IFB #25-100
1900 2nd Ave North, Community Sustainability
Expansion Project

Change Order Requests

1900 2nd Ave North, Community Sustainability Expansion Project

CHANGE ORDER REQUESTS

[20260227-LWB Community Sustainability Expansion_SSK-003.pdf](#)

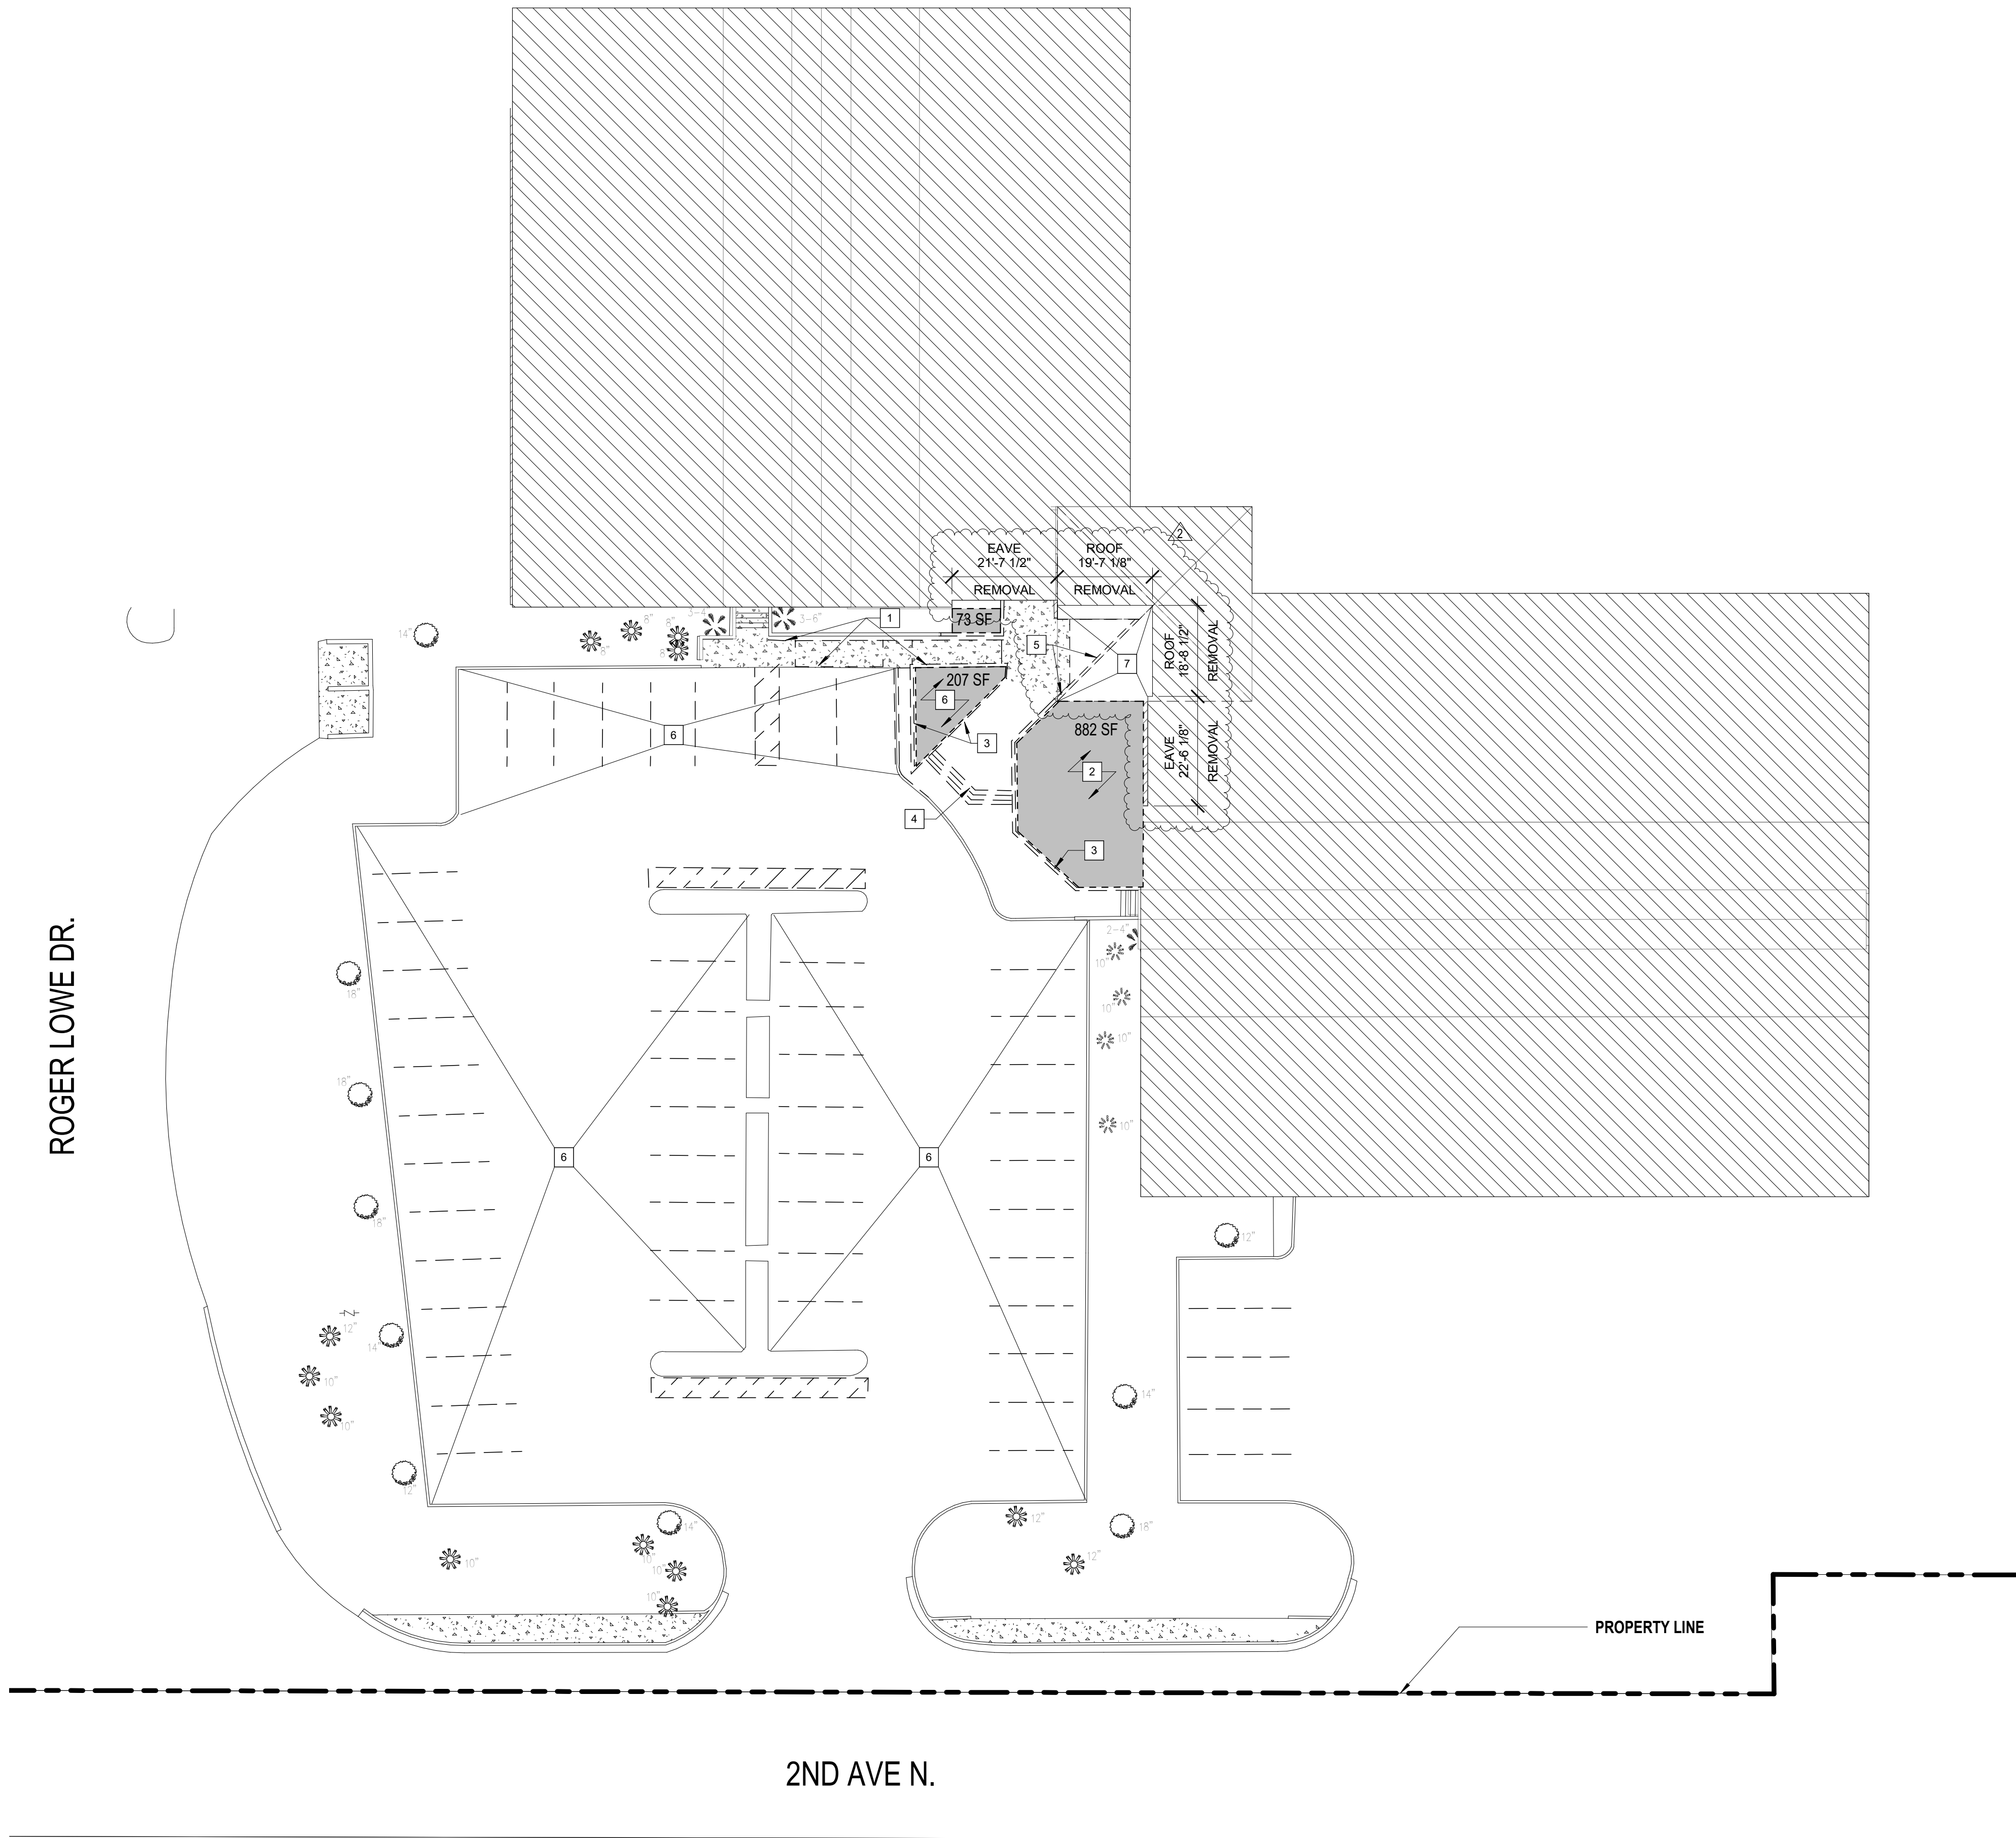
A section of the existing roof conflicts with the new addition's roof at the entry. Neither the S-101 floor demo nor the demolition drawings D-201 and D-203 indicate the demolition of the roof. If the existing roof is to be demolished, please provide a drawing showing the area to be removed and the details showing the transition between the existing and the new roofs.

Attached is SSK-003 which shows modifications to the existing entrance roof to allow removal of the hip beam.

SITE DEMOLITION PLAN

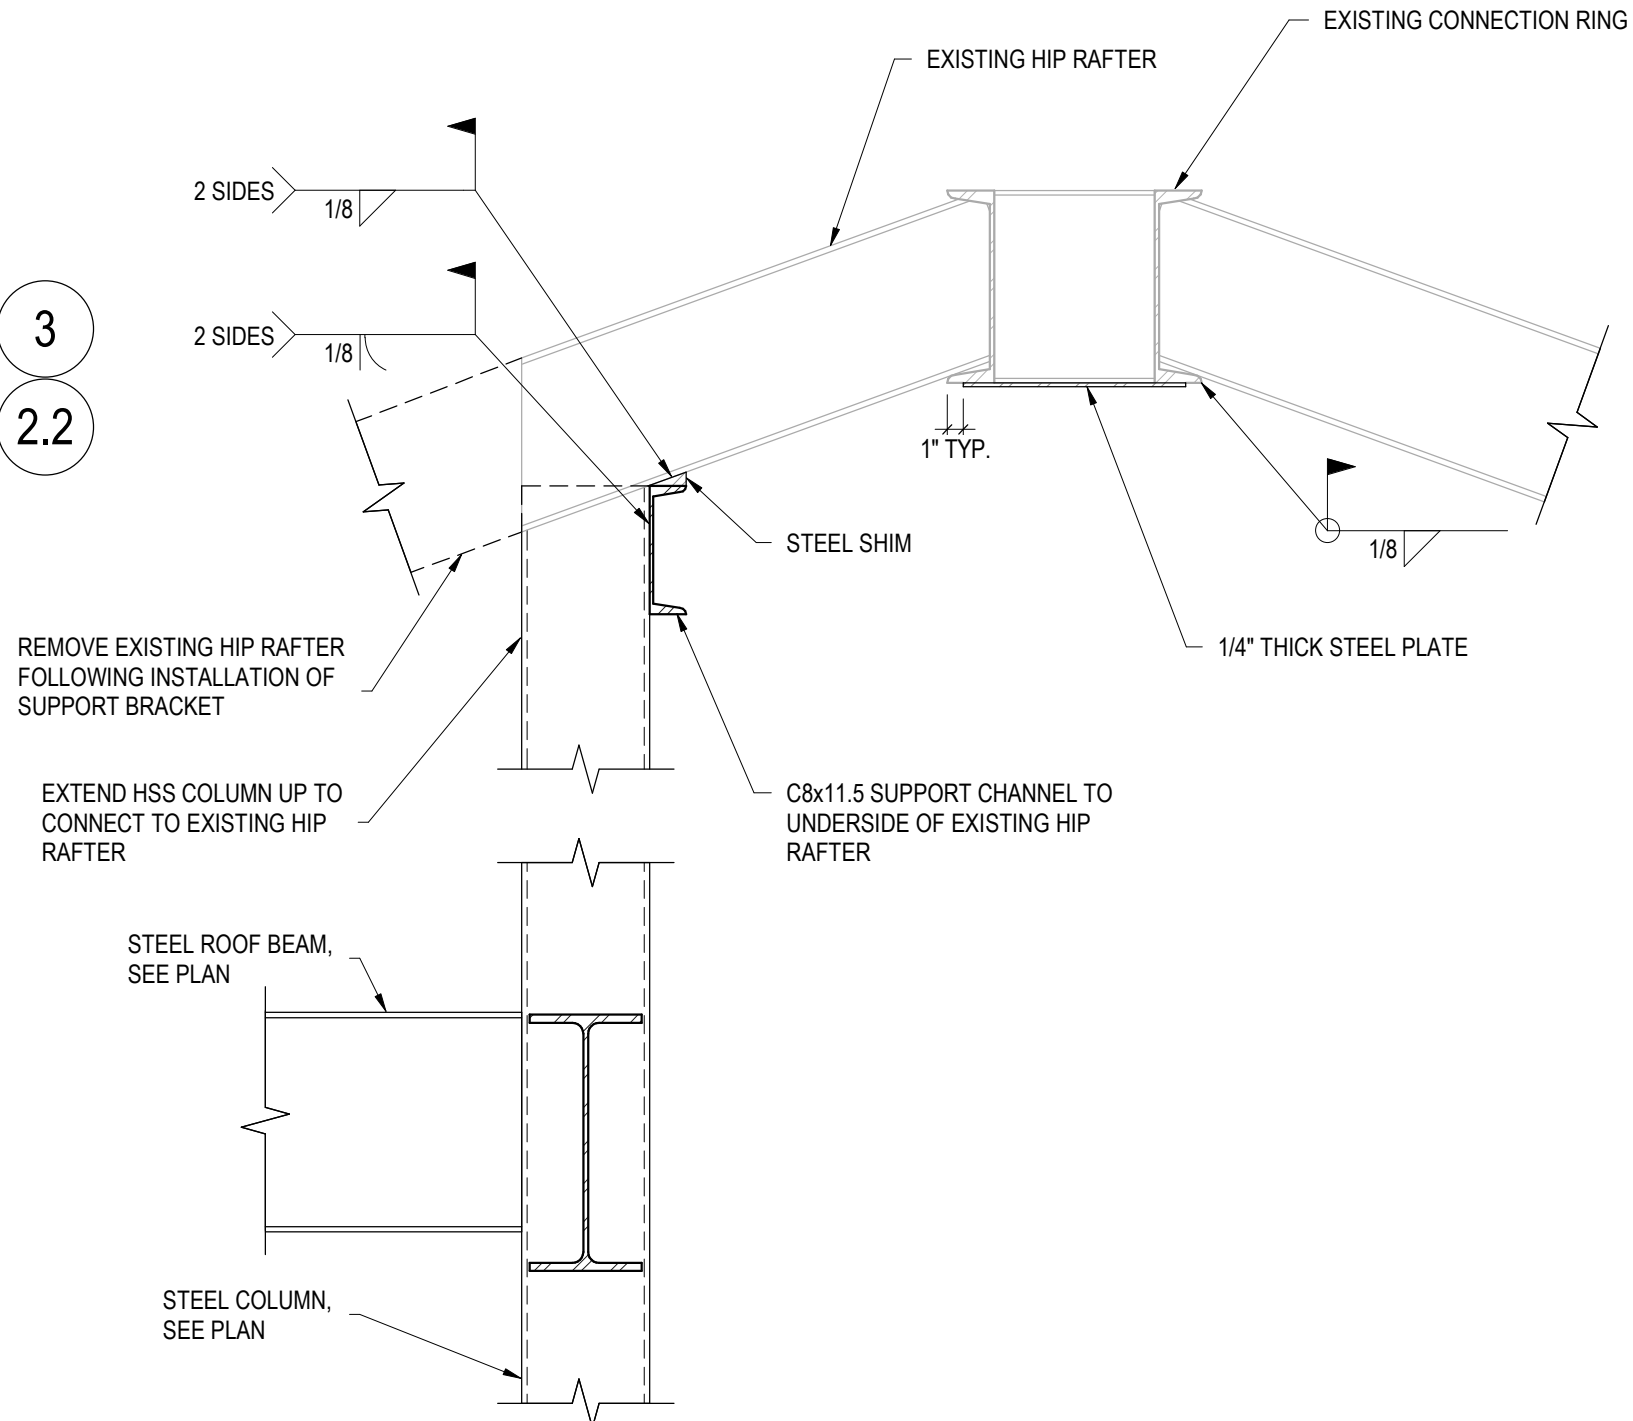
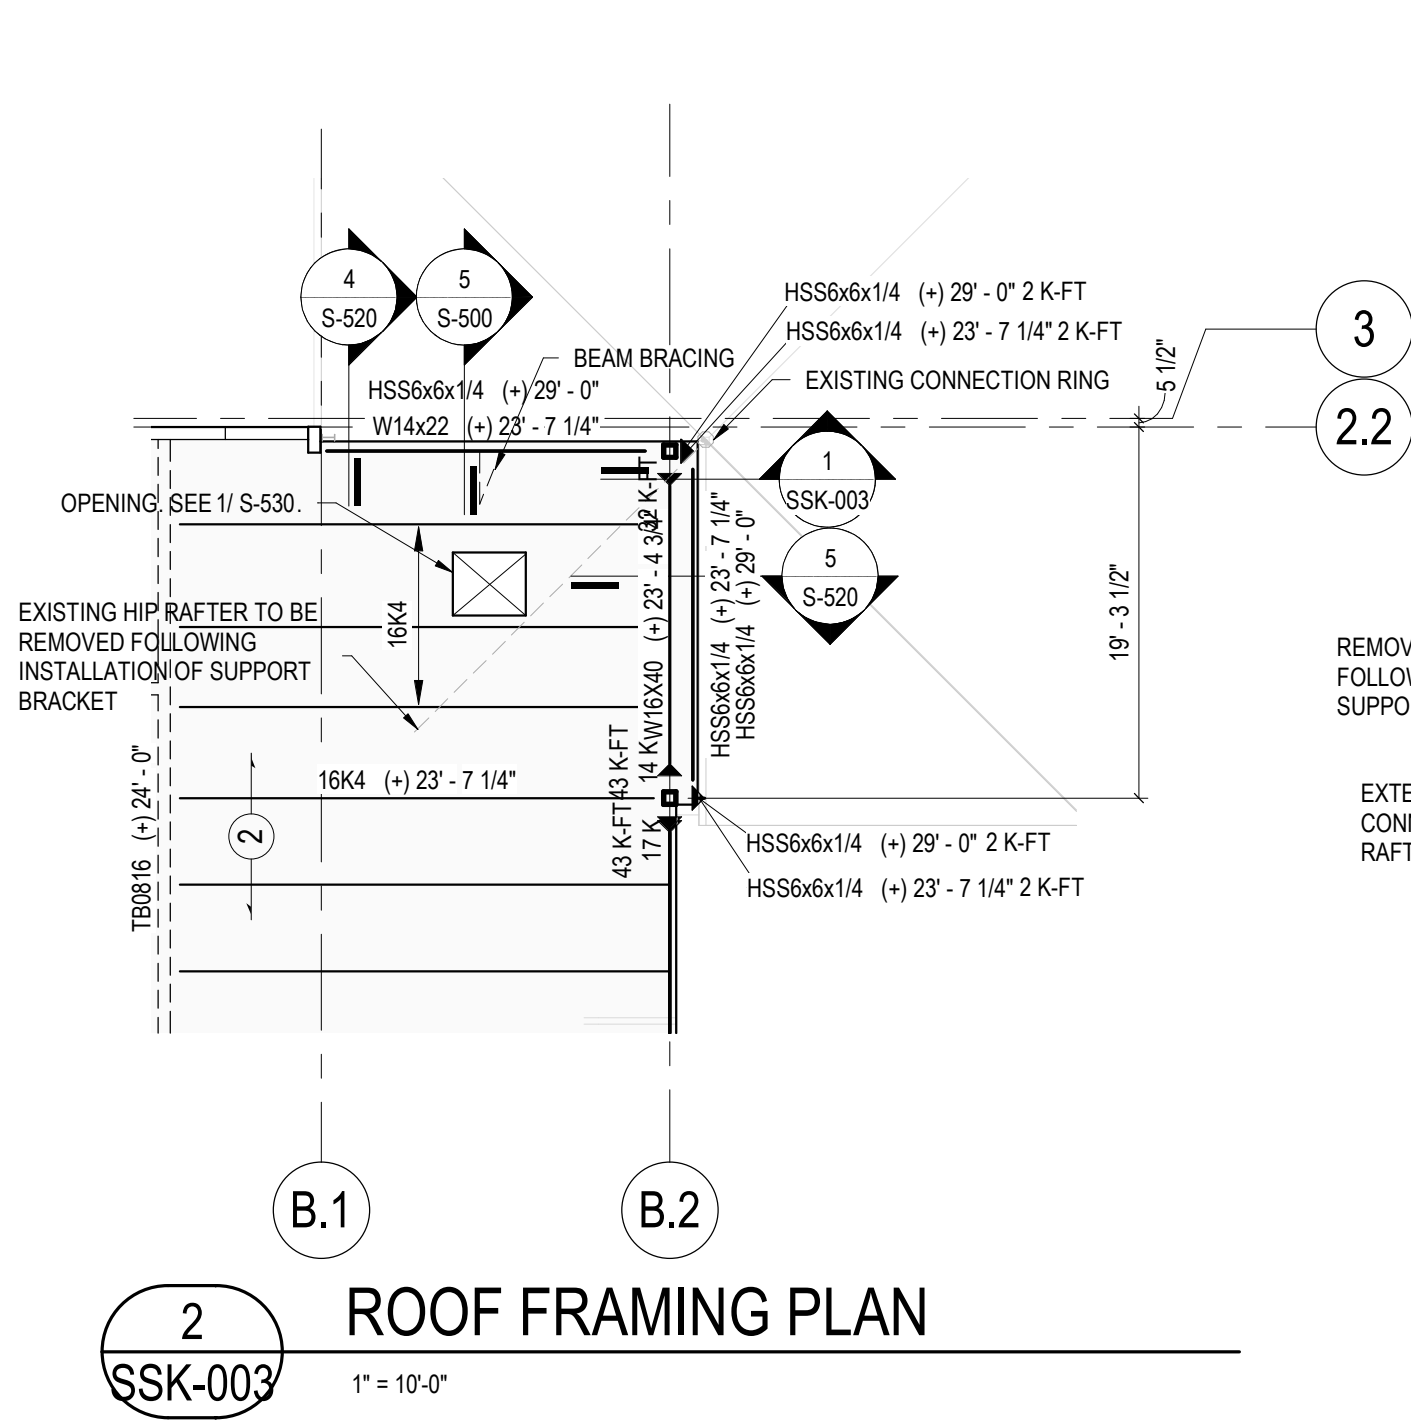
2- Please find attached updated demolition plan noting extent of existing roof and overhangs to be removed.

PHOTO TAKEN ON JOBSITE (01/28/2026)

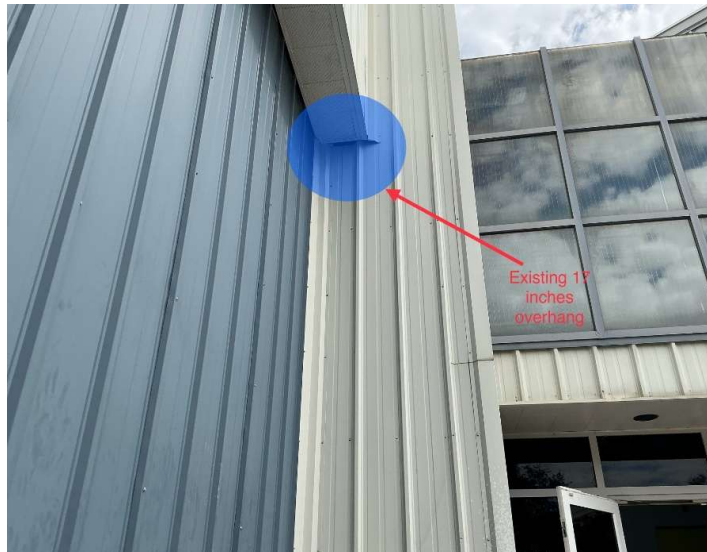
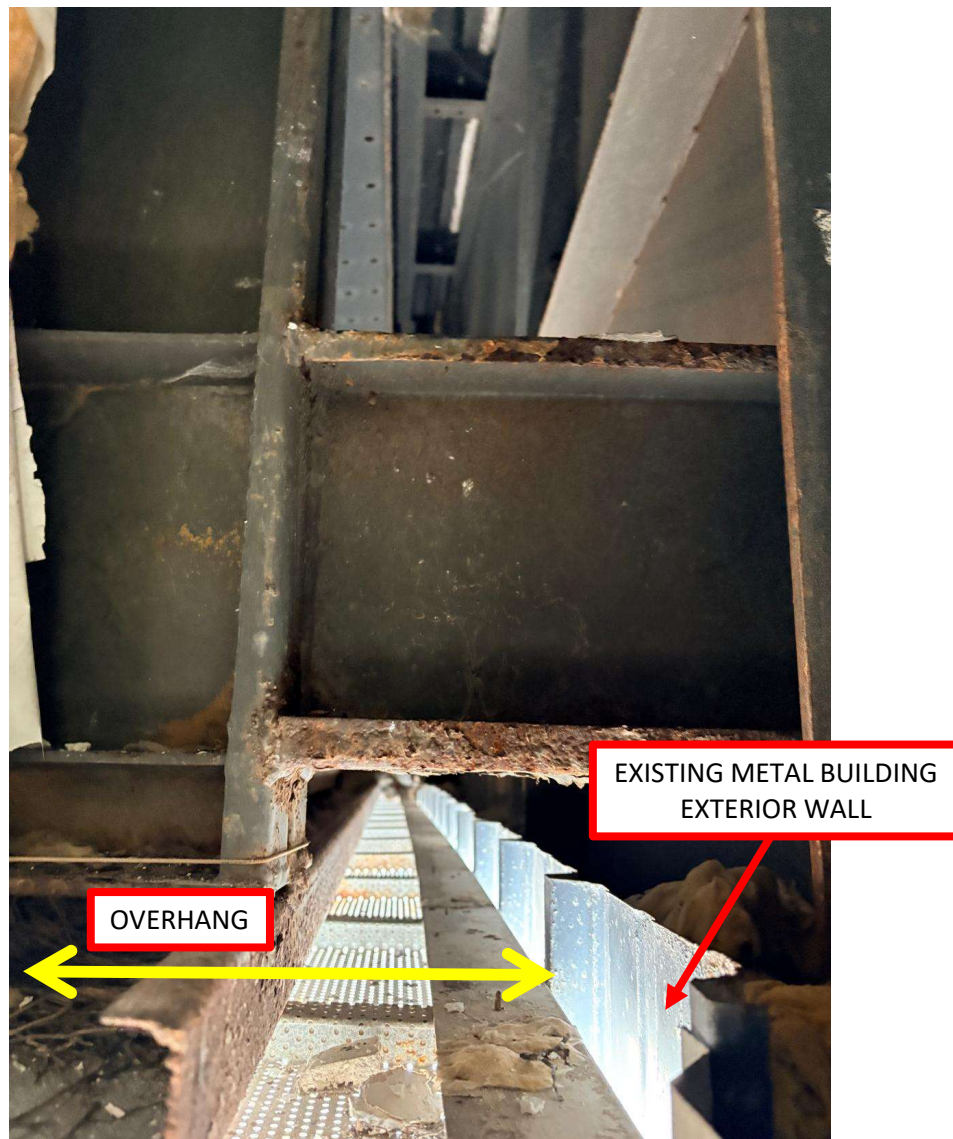
An existing overhang of 17" measured from the exterior face of the existing metal building (See attached photo taken on site) is affecting the design of the expansion building. As seen in the attached snips from the foundation plan (S-102) and wall section 2 (A-610), the overhang affects the location of the new wall on the Mezzanine level. We can't remove it since it's a structural element (See last picture). Please advise

Interior view of the overhang. Reinforcement shows that the overhang is a structural element
